**TOWN OF NEWBURGH  
PLANNING BOARD  
TECHNICAL REVIEW COMMENTS**

**PROJECT: DORRMANN SUBDIVISION**  
**PROJECT NO.: 21-03**  
**PROJECT LOCATION: SECTION 1, BLOCK 1, LOT 93**  
**REVIEW DATE: 29 JANUARY 2021**  
**MEETING DATE: 4 FEBRUARY 2021**  
**PROJECT REPRESENTATIVE: TALCOTT ENGINEERING**

**PROPOSED 2 LOT SUBDIVISION ENTITLED "DORMANN SUBDIVISION"**  
 WEAVER ROAD, SBL: 11-1-93  
 TOWN OF NEWBURGH, ORANGE COUNTY, NY

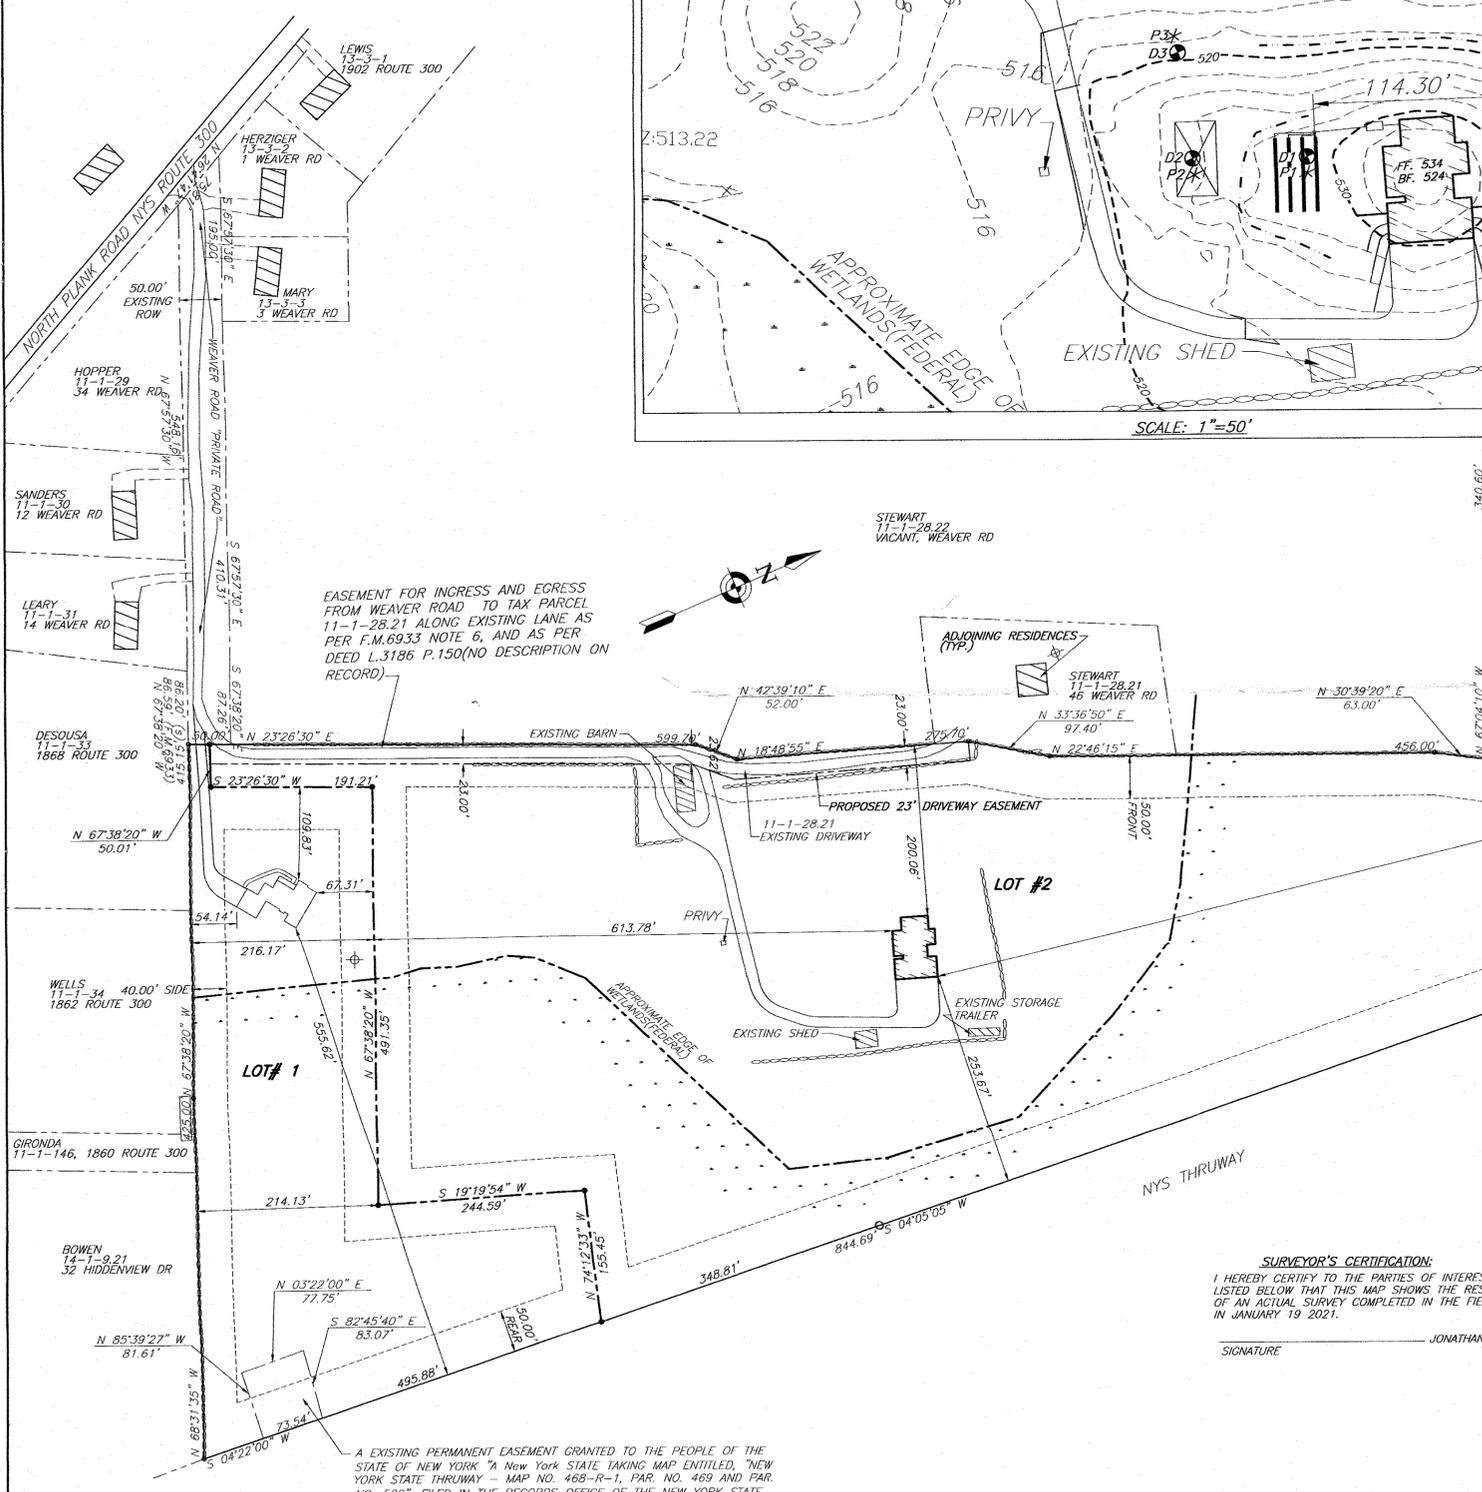
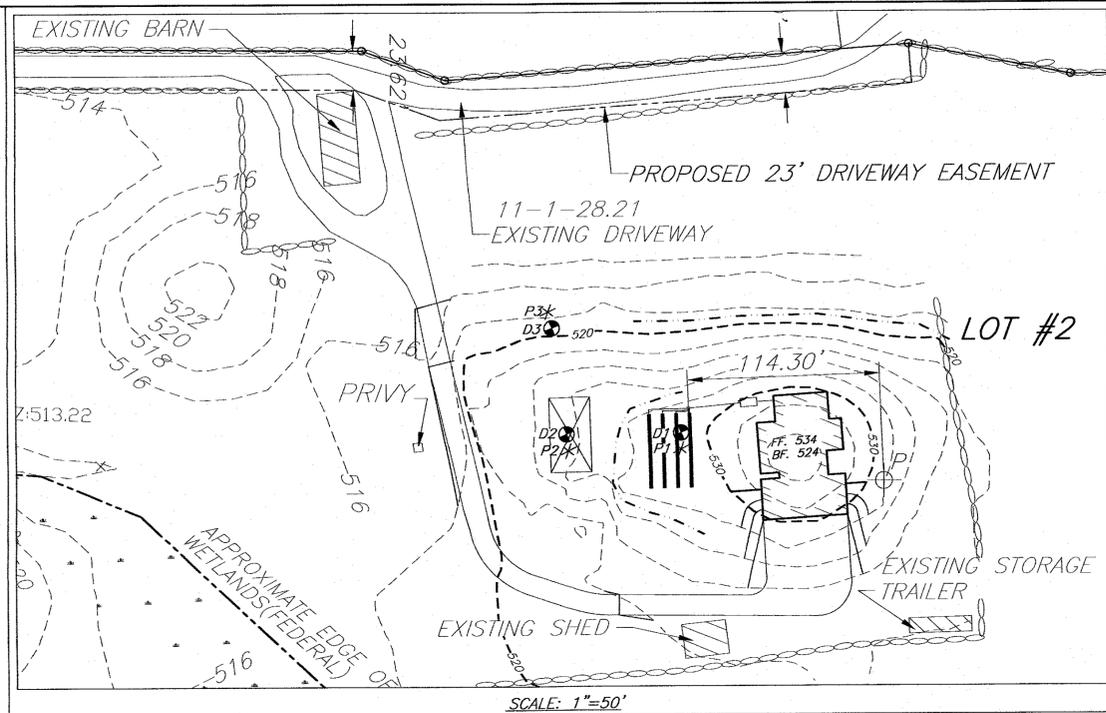
1. Information pertaining to the existing private roadway, Weaver Road, should be provided.
2. The amount of frontage depicted on Weaver Road for proposed Lot #1 should be identified on the plan.

3. An existing storage trailer is depicted on proposed Lot #2. Storage trailers are not permitted on residential lots.
4. Location of septic system on both lots must be depicted. Separation from adjoining wells on all surrounding parcels must be depicted.

5. A delineation of the Federal Jurisdictional Wetlands on the site should be submitted for the Board's use. Currently all wetland areas are identified as approximate.

6. Information regarding the proposed 23 foot driveway easement to adjoining lot, lands now or formally Stewart, Tax Lot 28.21 should be submitted for the Planning Board Attorney review. It appears that the creation of the easement will permit three houses on a new or extended access drive. A private road may be required based on the three houses utilizing what is identified as a proposed easement.

7. The Planning Board should discuss the topography depicted only on the inset plan. Town subdivision regulations require topography to be depicted on the lot. Town Planning Board would have to issue a waiver if entire site topography is not depicted.
